Summit County Planning Commission (SCPC)

Thursday, February 22, 2024 - 3:00 p.m.

Meeting Agenda

Planning Commission
Preliminary Plan
Kingdom Preserve
Springfield Township

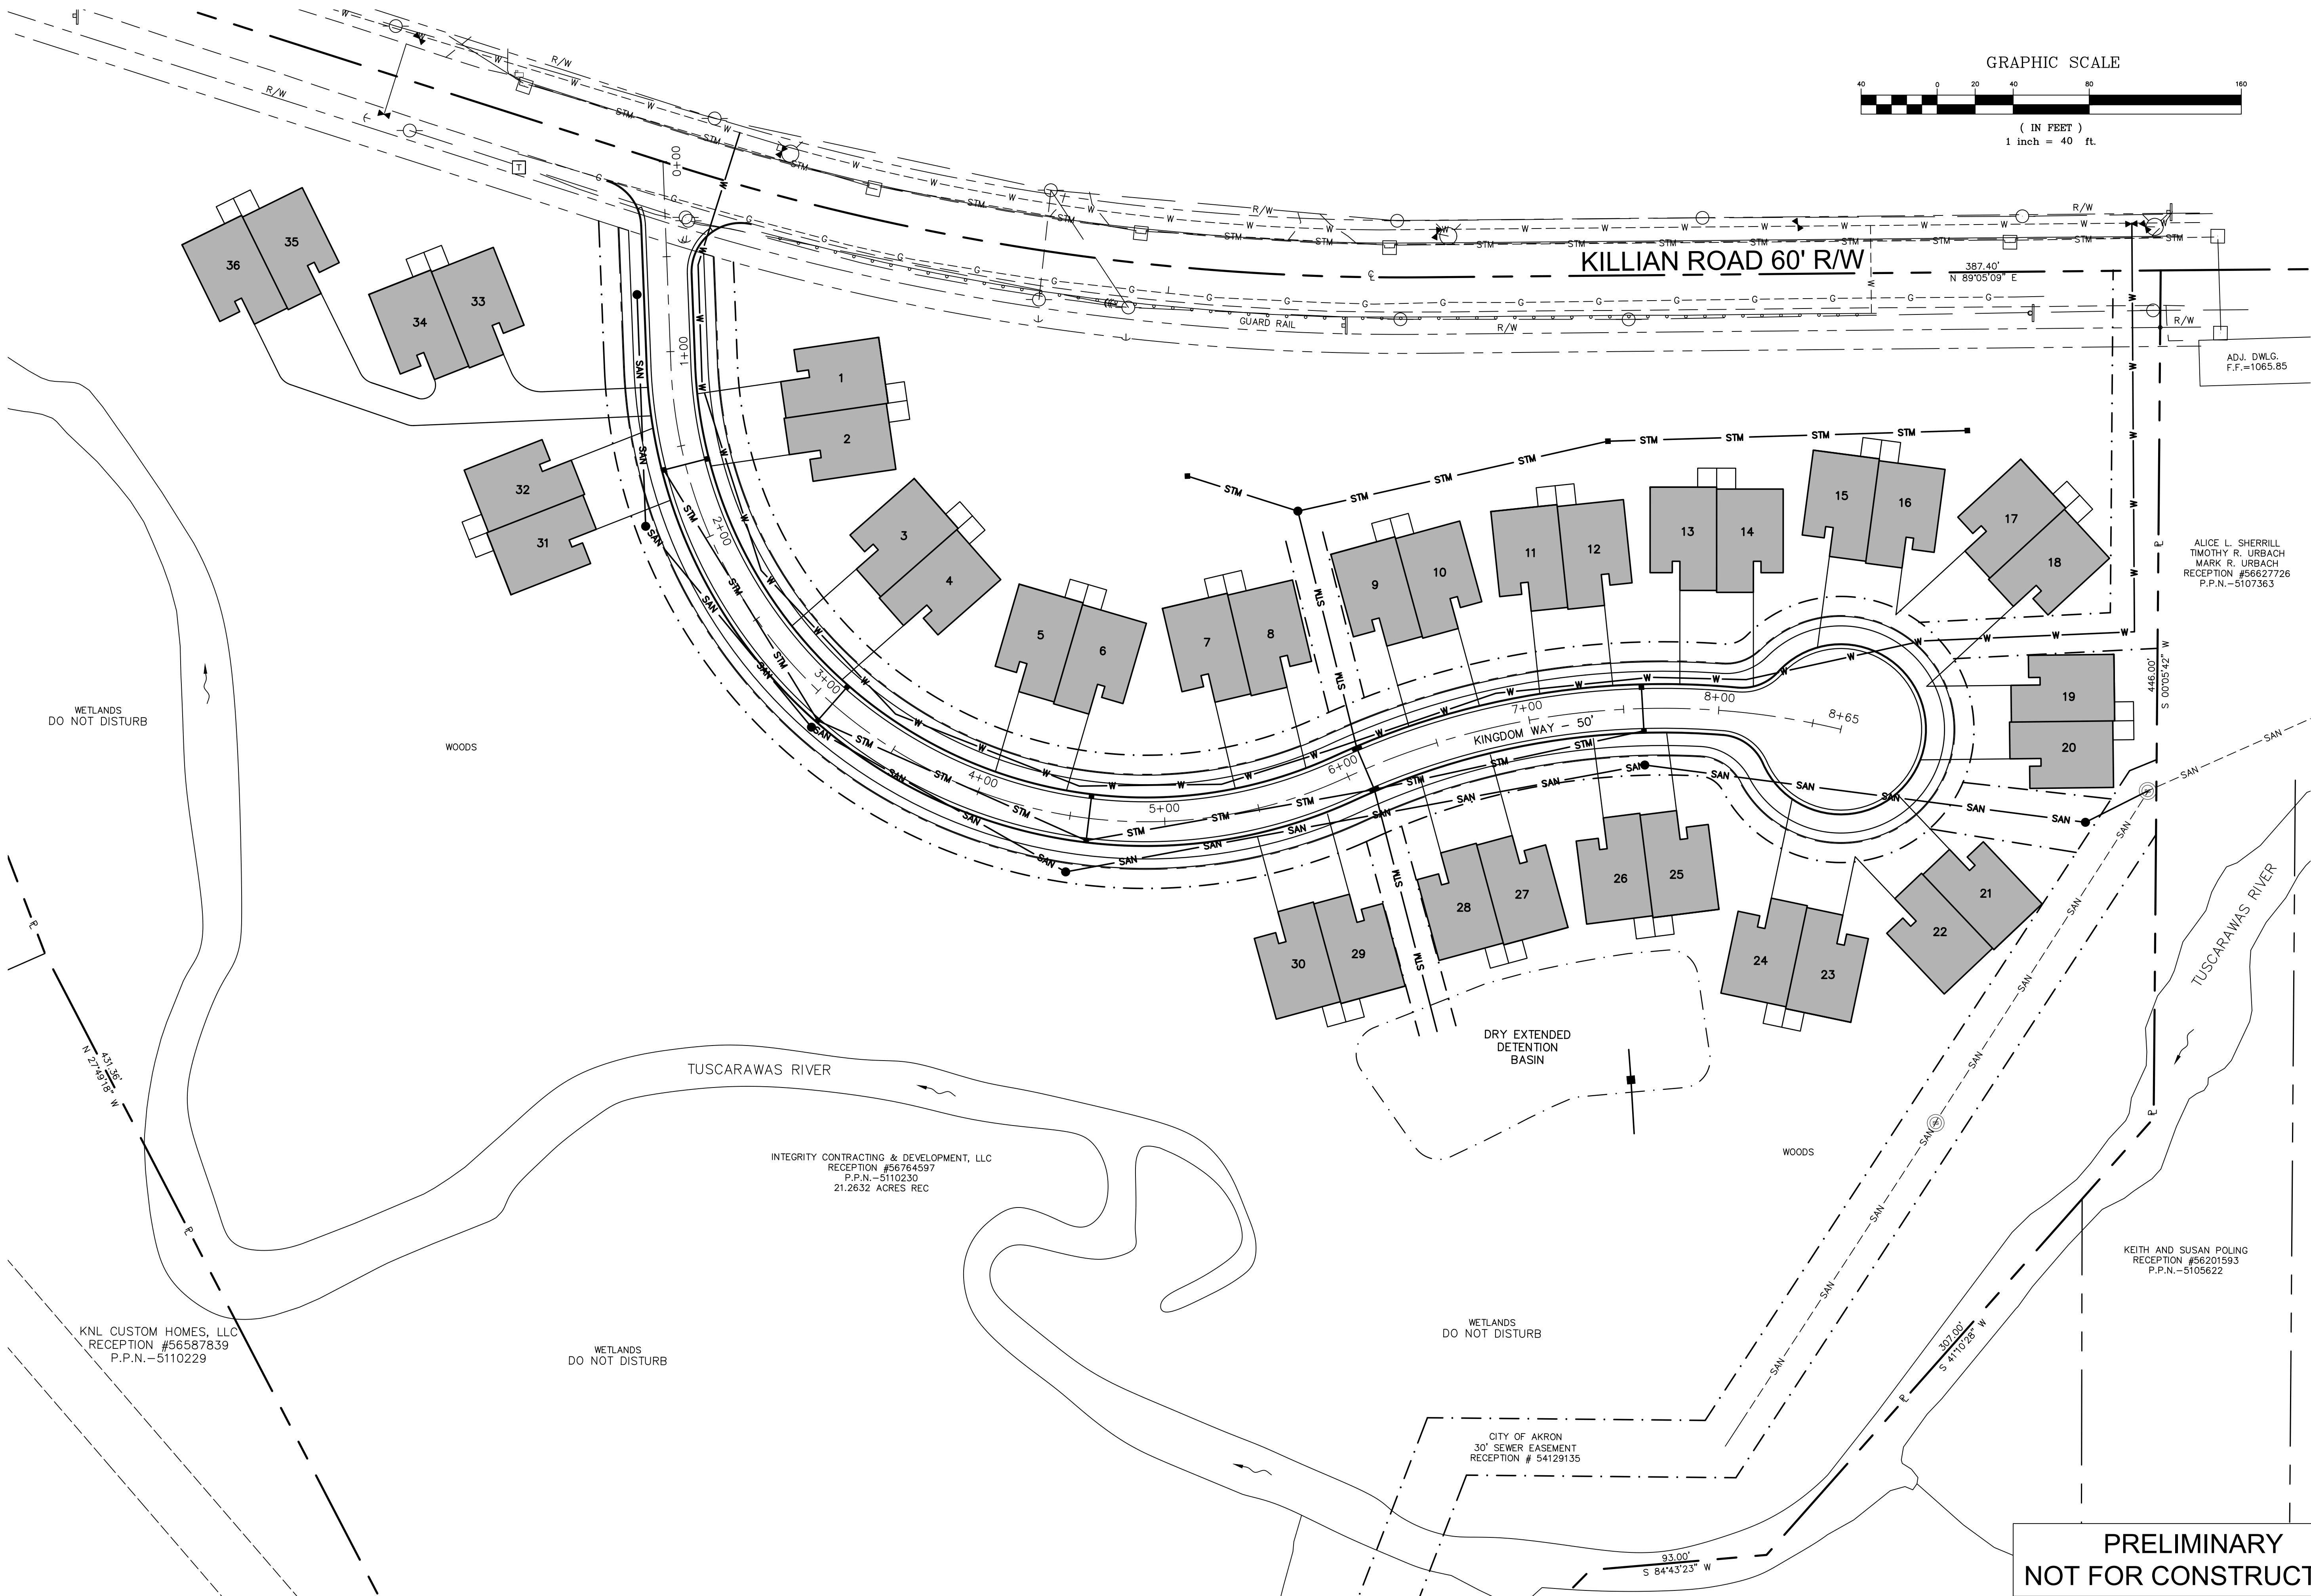
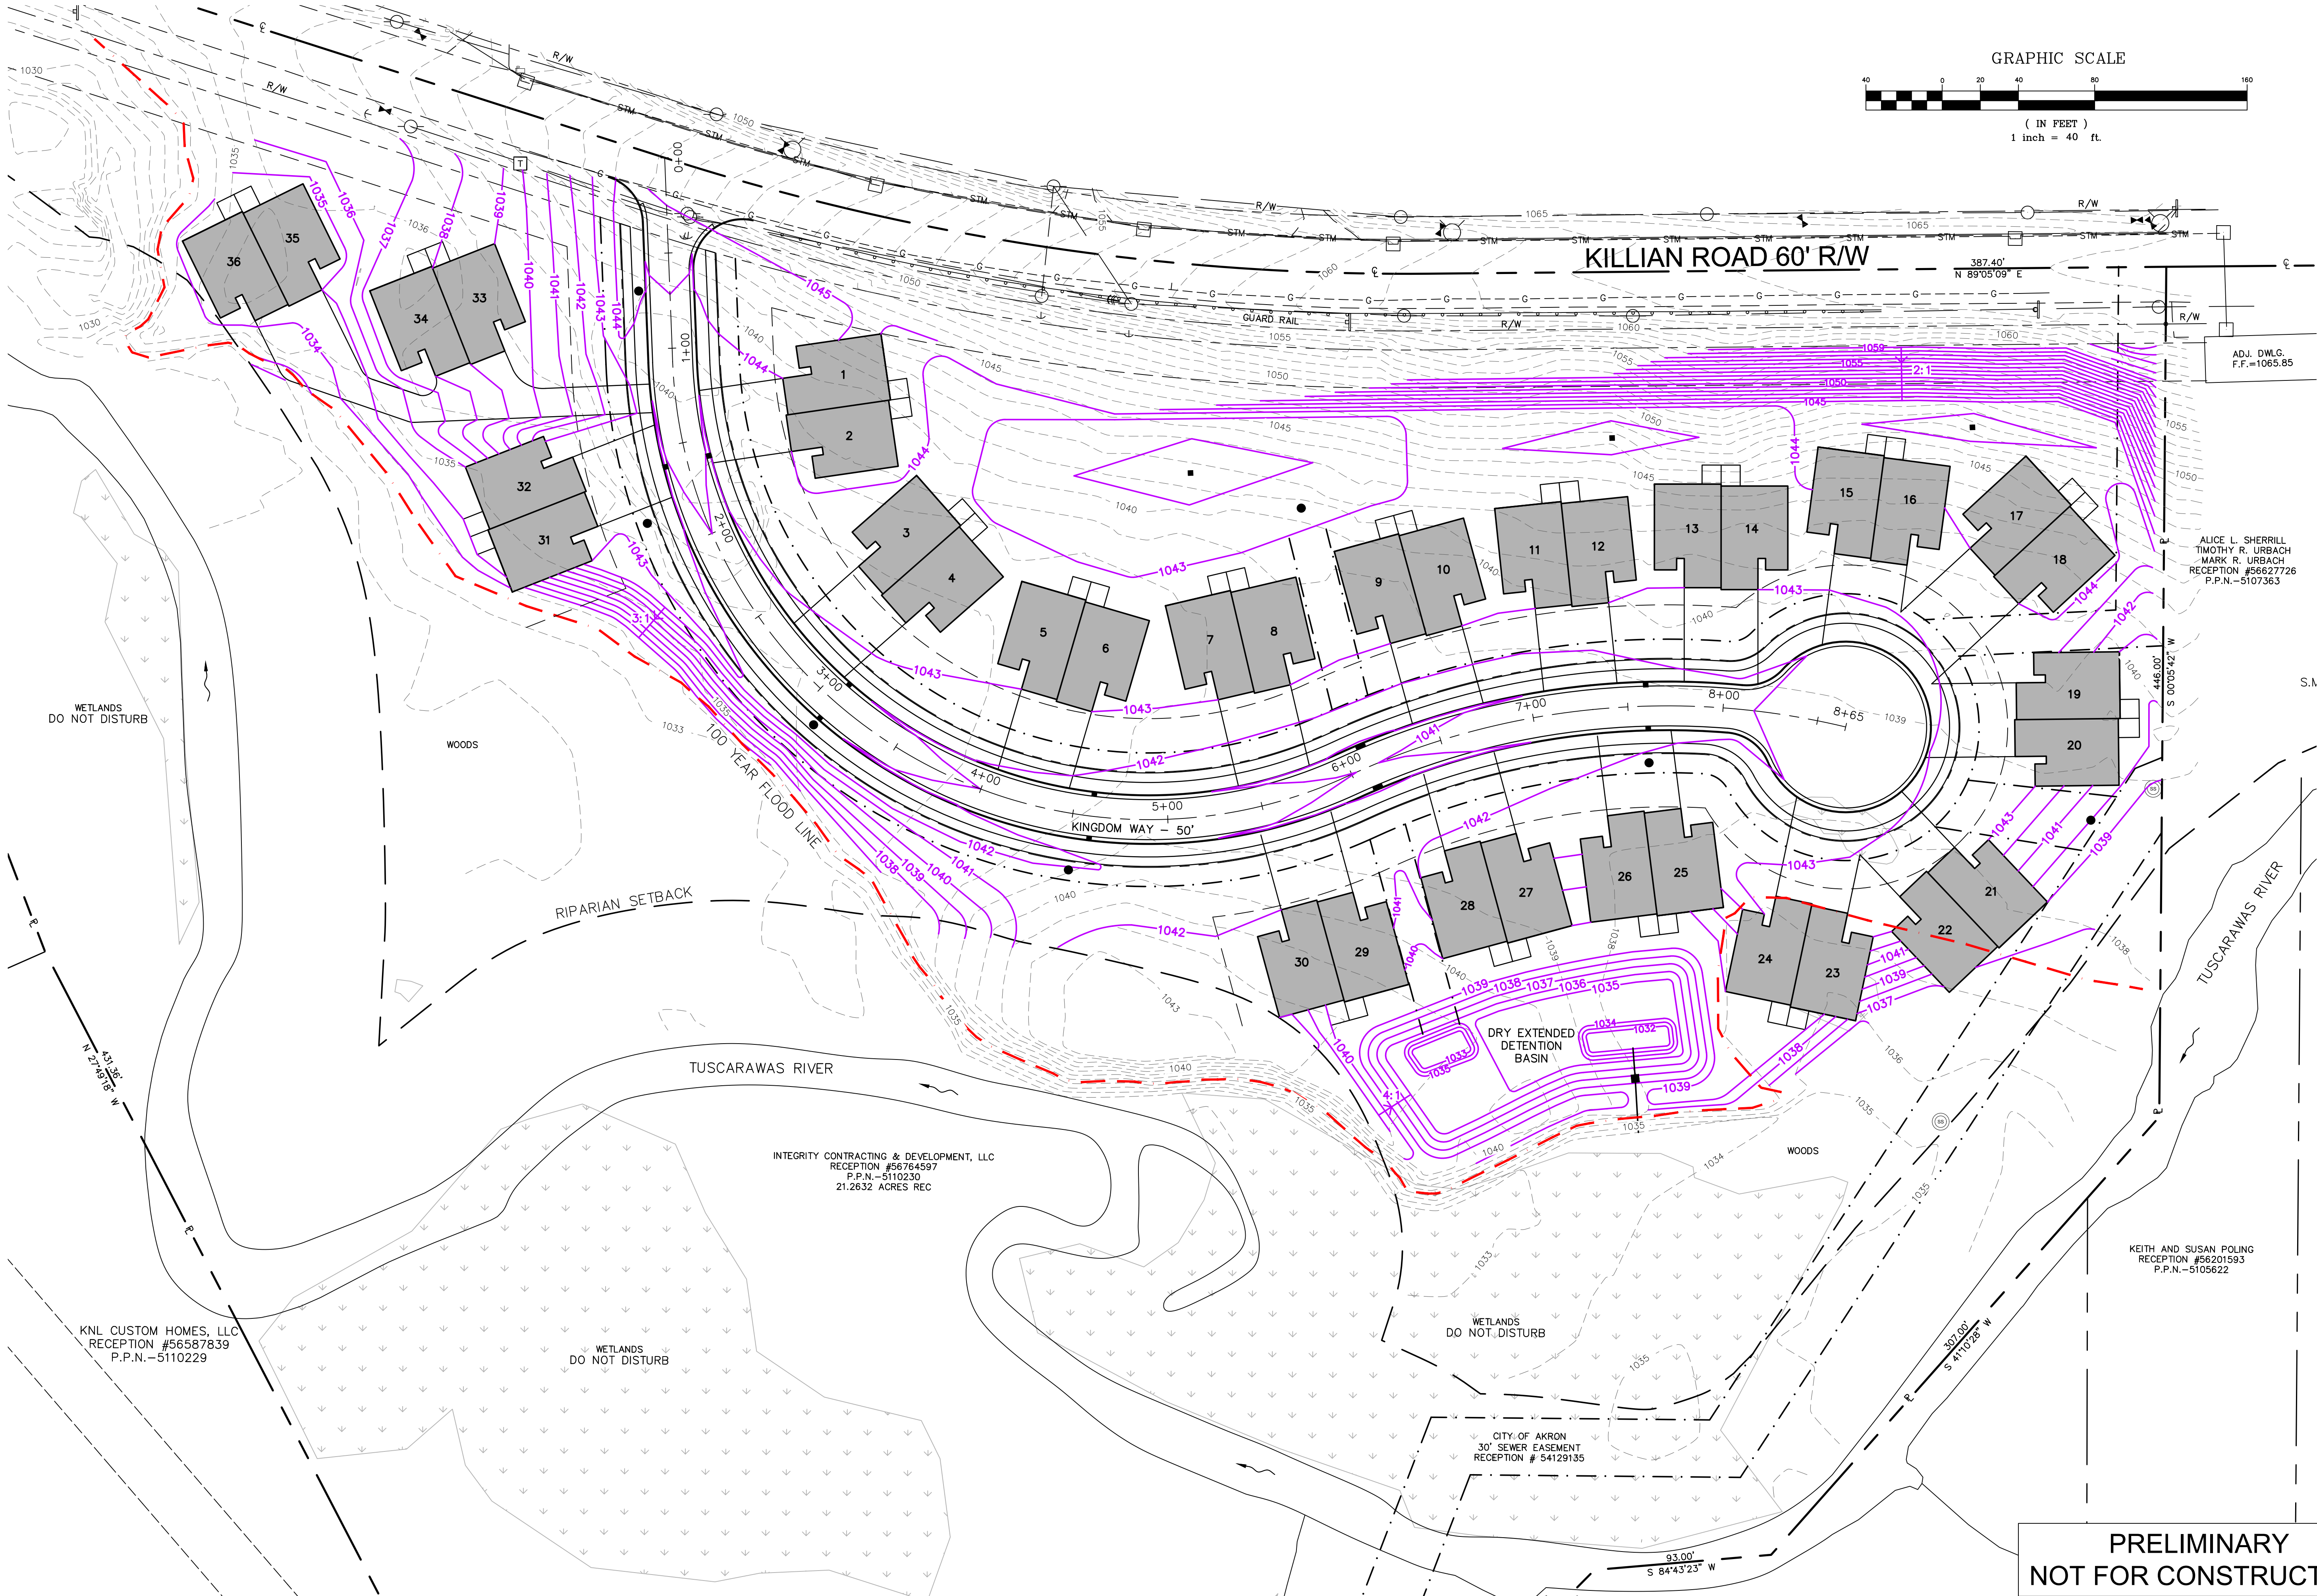
SCE: Andy Dunchuck, 12/18/2023: *Our office has reviewed the above referenced and attached Preliminary Plan and has the following comments. If you have any questions regarding this matter, please contact our office.*

1. *All Stormwater Management for the site must follow the SCE Stormwater Drainage Manual, Current Edition (Revised 1/1/20). All SWM Facilities must be located outside of the Wetland and Riparian Setbacks and the 100-Year Flood Plain. In addition, the outlet pipe for the proposed SWM Basin must have an adequate outlet.*

4. *The Intersection Sight Distance for proposed access onto Killian Road must be verified for a Design Speed equal to 45-mph.*
5. *A Traffic Impact Questionnaire for the project must be completed to determine if additional Studies are warranted.*

6. *Since the proposed road will be servicing 36 Units, the road is classified as a Residential Medium Traffic Road which requires a minimum 26' Wide Pavement (Curb and Gutter) or 24' (Open Ditch). In addition, the plan indicates a 50' Access and Utility Easement in lieu of R/W. Is this being proposed as a Private Subdivision?*

11. *Provide a Wetland Delineation for the Project.*
12. *Part of Unit 22 and all of Units 23 and 24 are located within the 100-Year Flood Plain.*

-
13. *The Proposed Utilities must be located outside of the pavement.*
 14. *A Road Opening Permit will be required for the proposed work within the R/W of Killian Road*

1. *It does not appear that our Riparian setback standards have been taken into account. All of our setback standards have greater adjustments than Summit County's as of July 2023. I have attached the entire Riparian Setback Standards document. I have also attached parts of this document where I have highlighted sections that show greater adjustments that would apply. From what I can tell, it looks like condo 21, 22, 23, 24, 29, 30, 35, 36 may all be affected.*
2. *As for rear setbacks, condo 1, 18, 19, 20, 33, 35 may not be set back at least 40'.*
3. *Is there 10' between all condos at their closest points?*
4. *Does the common drive allow a 10' easement next to it? What is the width of it and there is no turn-around.*
5. *Is the distance between the rear of condo 34 to the front of condo 35 at least 60' and condo 25 to 24?*
6. *Is this a private road or a public road?*

Recommendation: It is Staff's recommendation that the SCPC **Table** this Preliminary Plan so the applicant can address Township and SCE concerns and to submit applications for any variances required.
